SECTION 00 9112 - ADDENDUM NUMBER 2

1.02 PROJECT: USC BARRINGER HOUSE MECHANICAL RENOVATION

1.03 OWNER'S PROJECT NUMBER: H27-Z335

sheet title
PLUMBING DETAILS, GENERAL NOTES,
PLUMBING LEGEND & ABBREVIATIONS

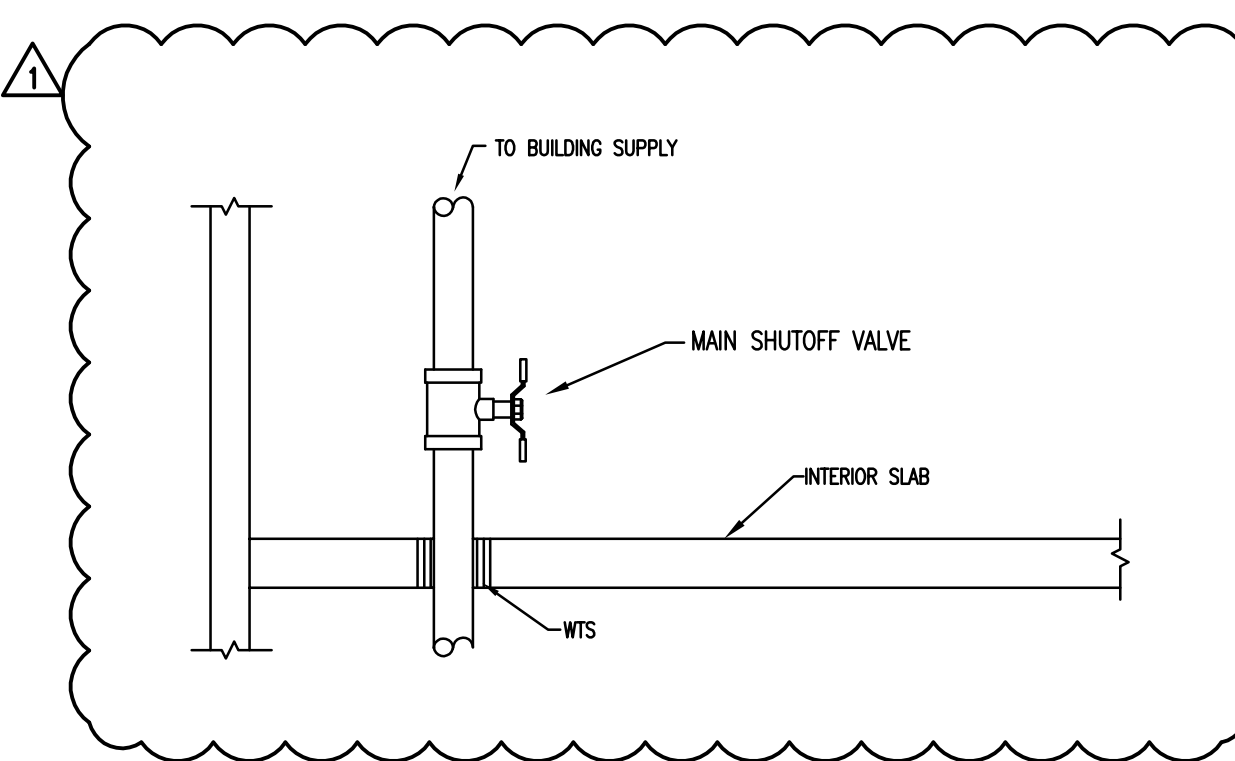
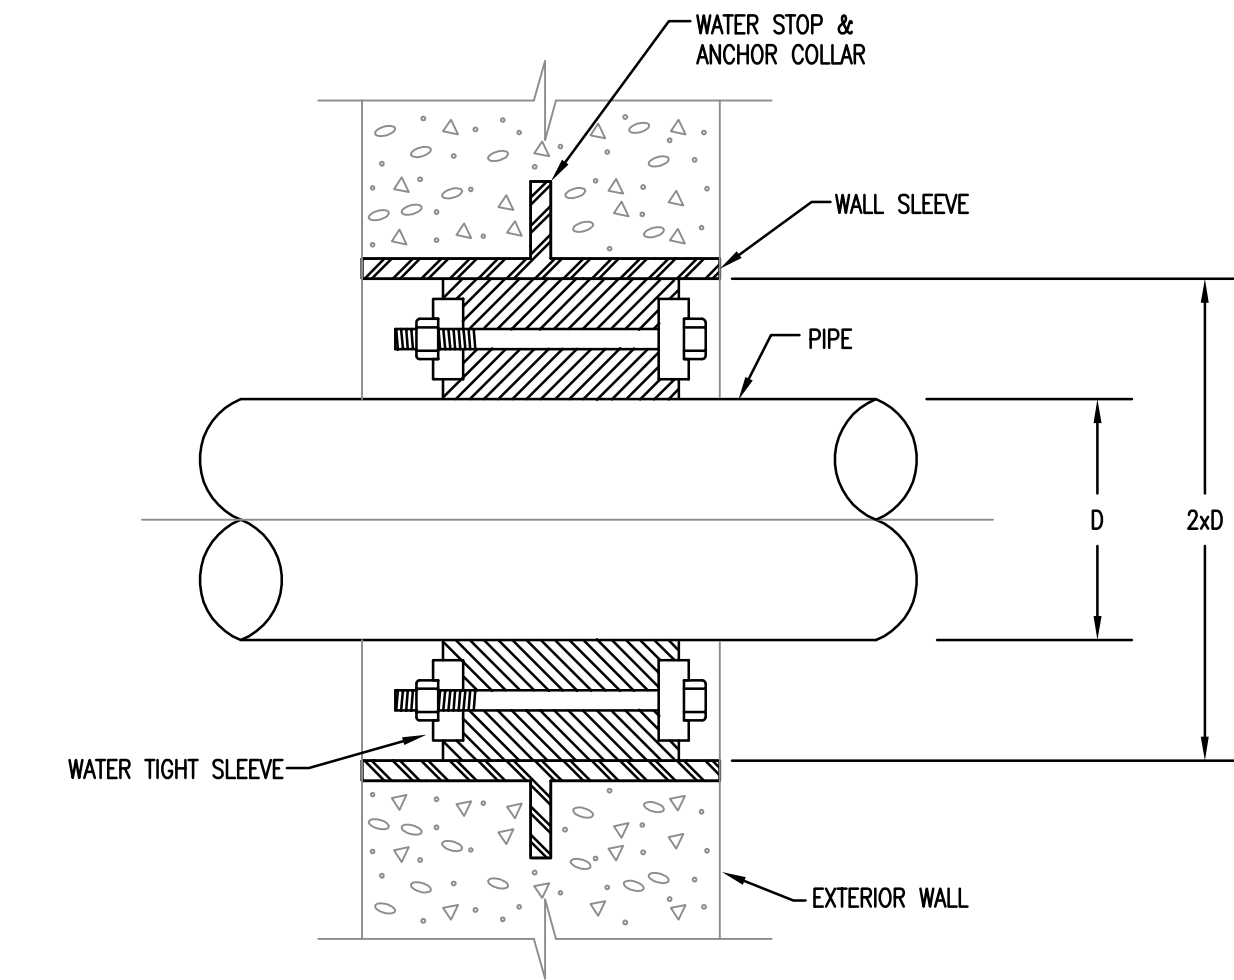
3.03 DRAWING P0.0 - PLUMBING DETAILS, GENERAL NOTES, PLUMBING LEGEND & ABBREVIATIONS

- A. Replace the existing drawing P0.0 in its entirety with the revised attached drawing P0.0.
 - 1. The Owner will construct the domestic water line to within 5'-0" of the building foundation wall. The Contractor is to connect to the Owner supplied domestic water line at 5'-0" outside of the building as indicated.

3.08 DRAWING M1.1 - HVAC DEMOLITION FIRST FLOOR PLAN

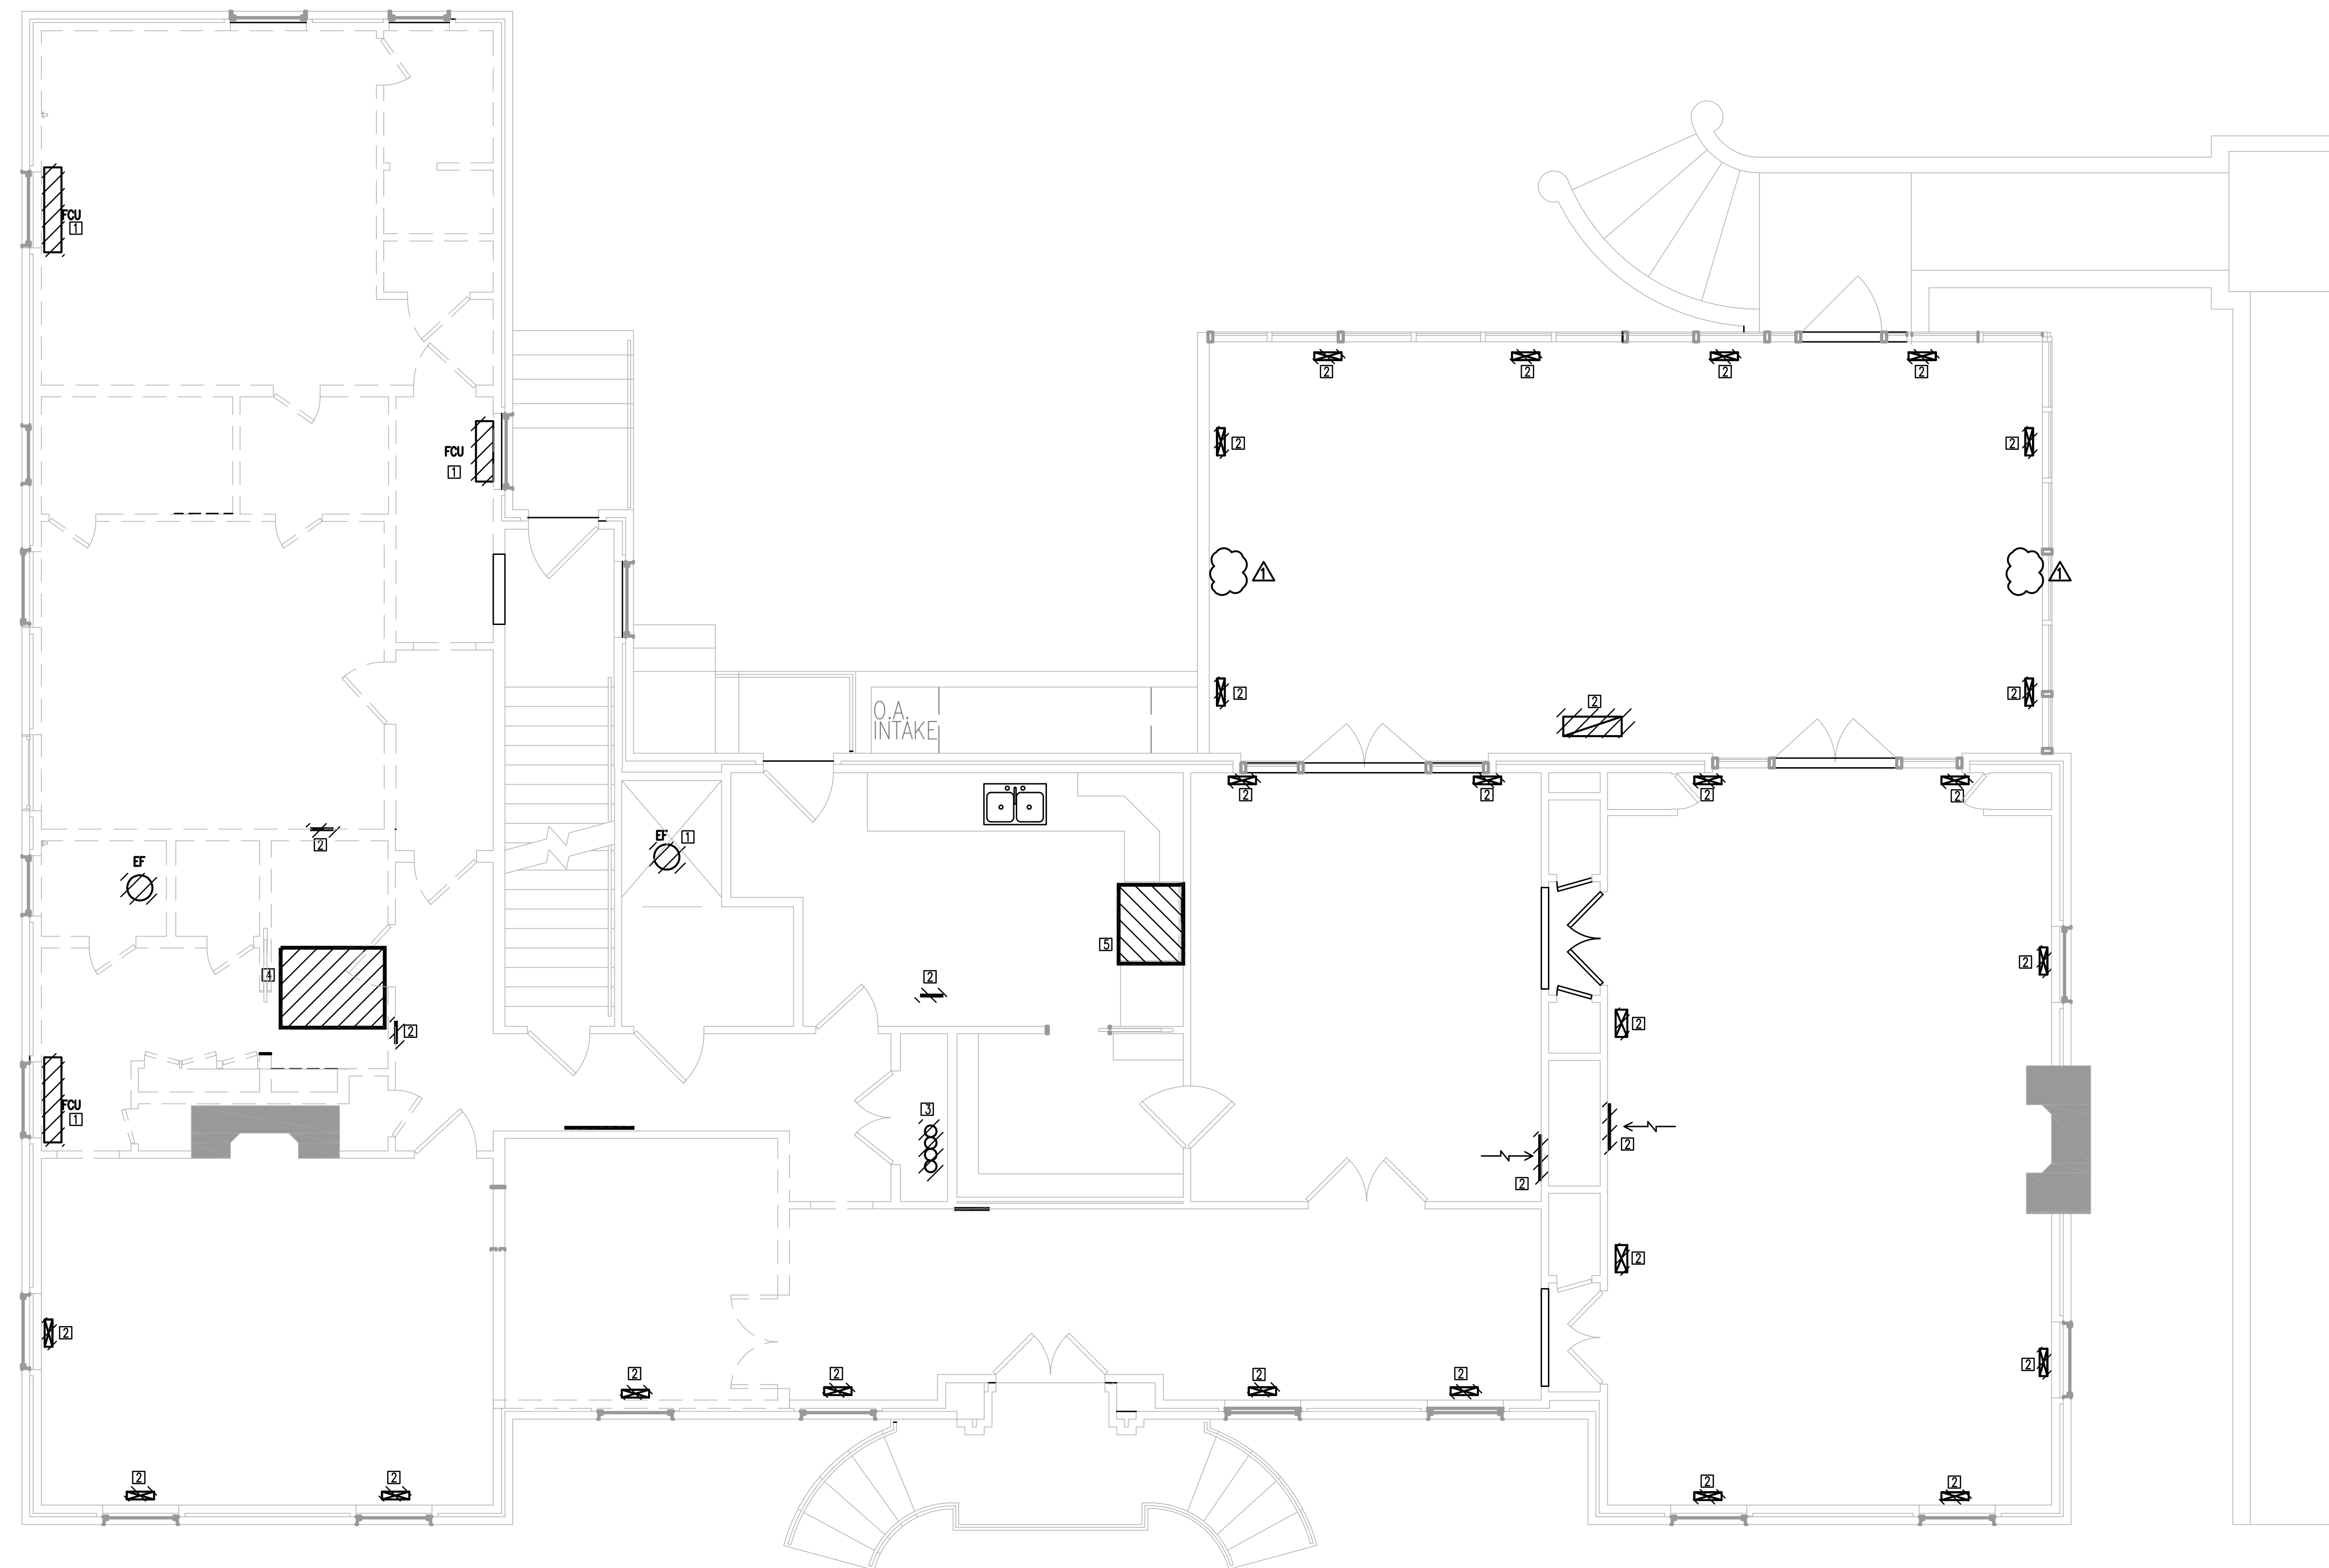
- A. Replace the existing drawing M1.1 in its entirety with the revised attached drawing M1.1.
 1. Revisions to the demolition, ductwork and diffusers are indicated.

sheet title
**HVAC
DEMOLITION
SECOND FLOOR PLAN**

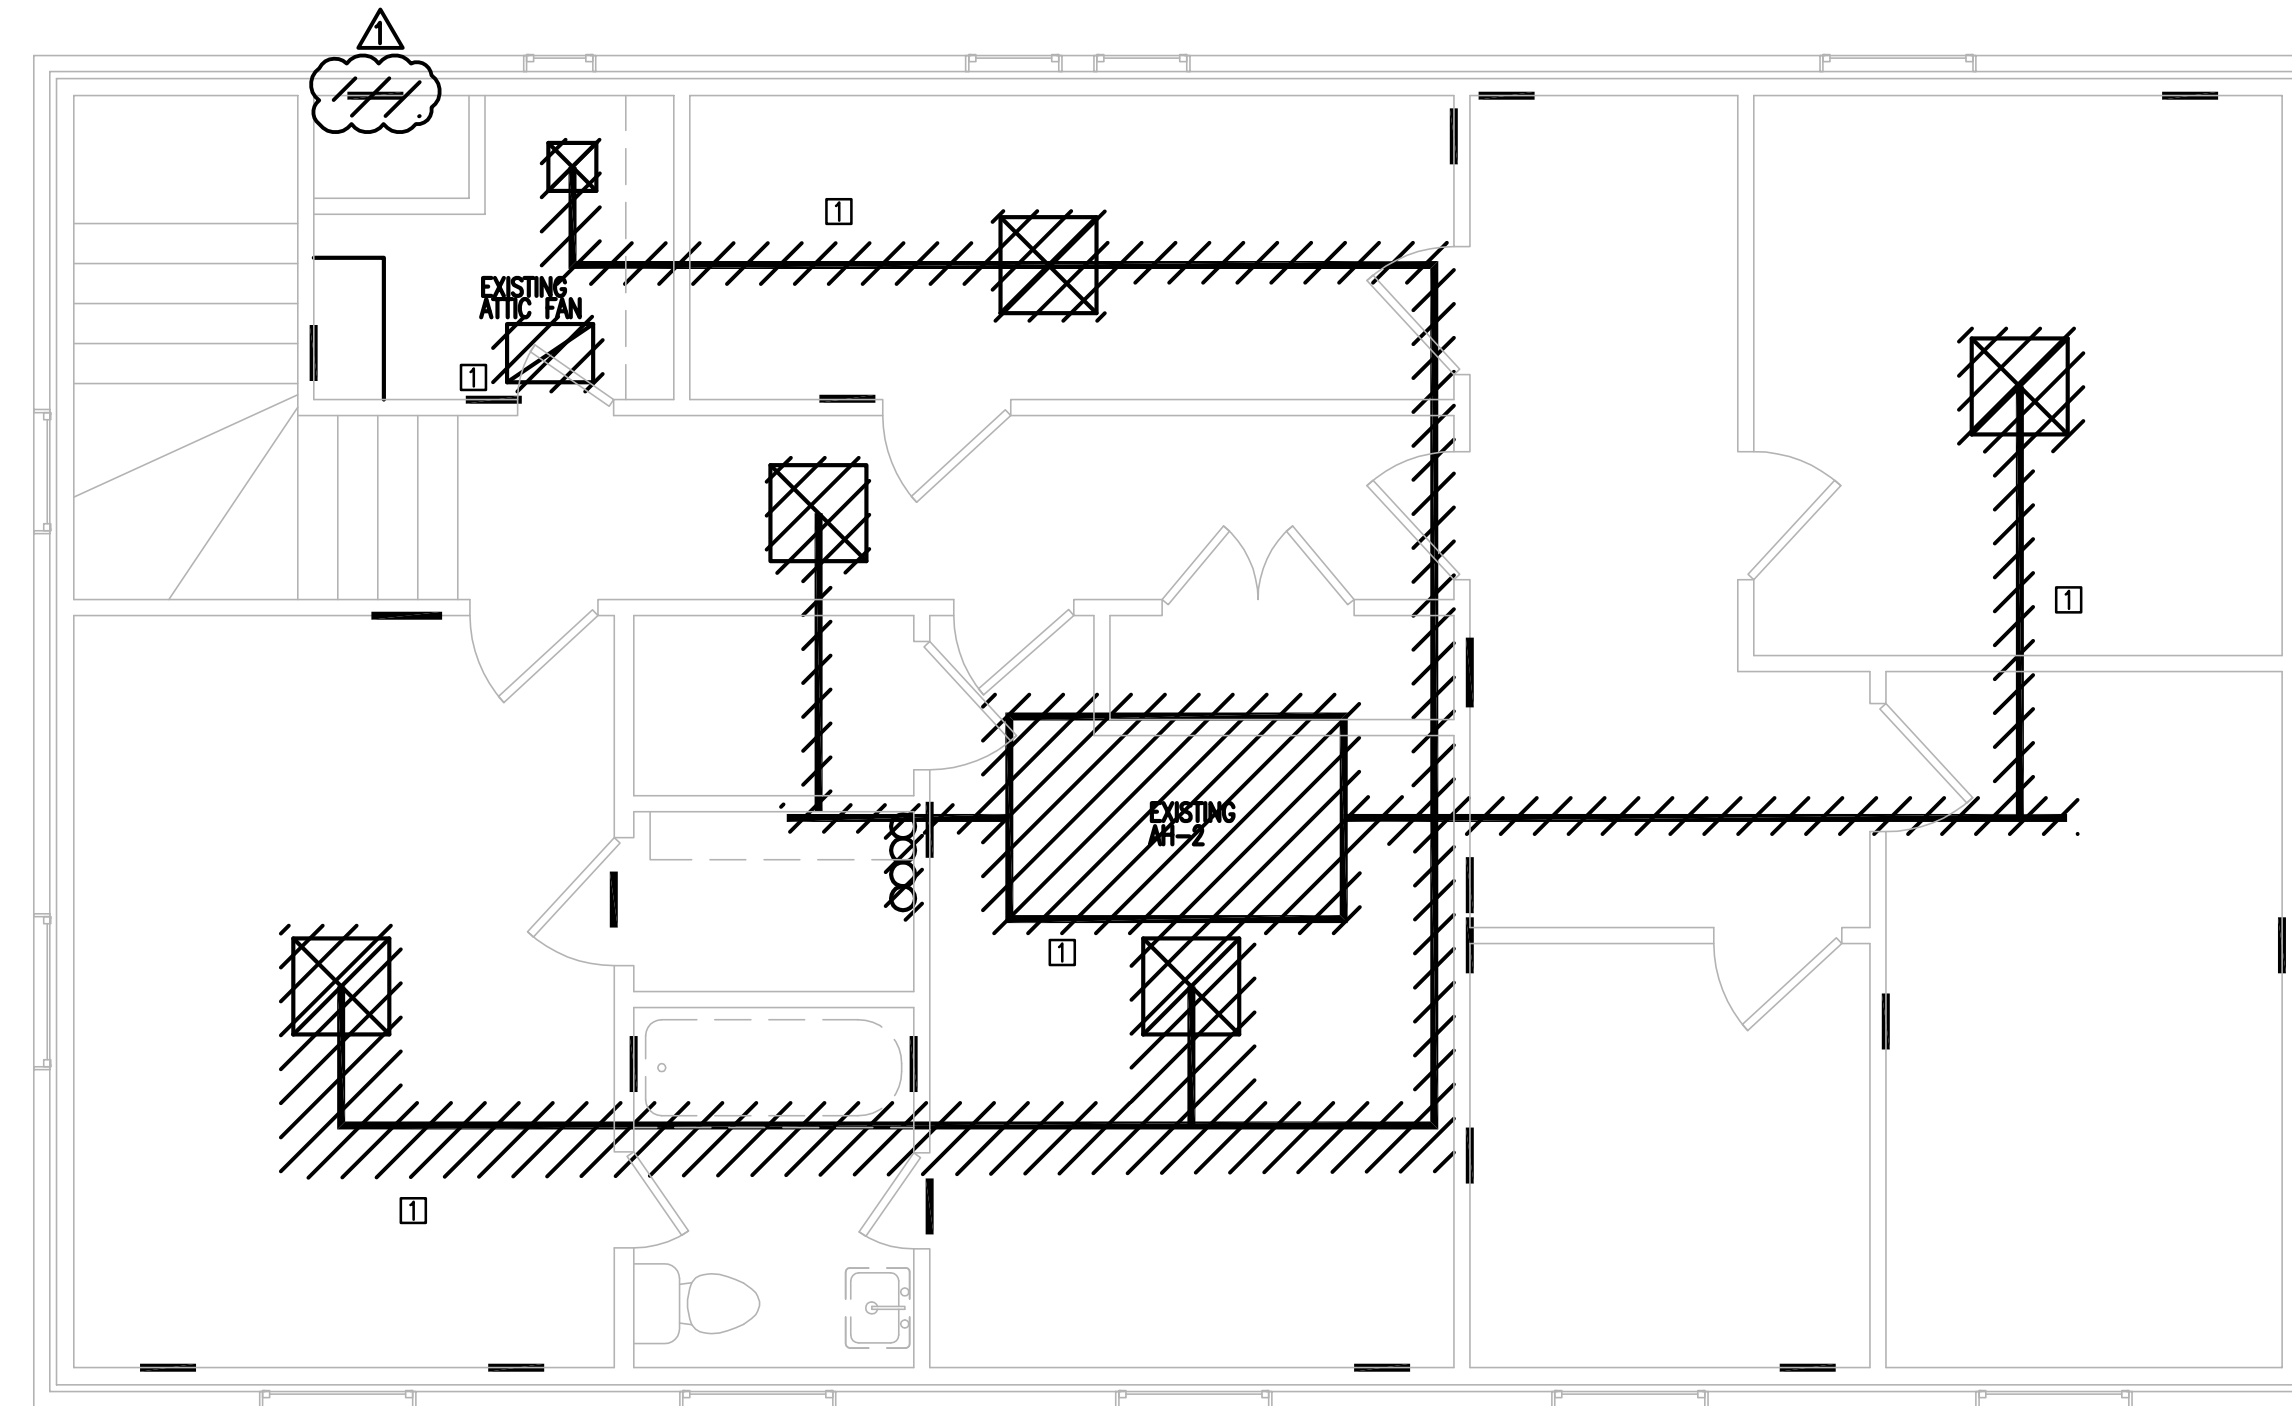
3.09 DRAWING M1.2 - HVAC DEMOLITION SECOND FLOOR PLAN

- A. Replace the existing drawing M1.2 in its entirety with the revised attached drawing M1.2.
 1. Revisions to the demolition, ductwork and diffusers are indicated.
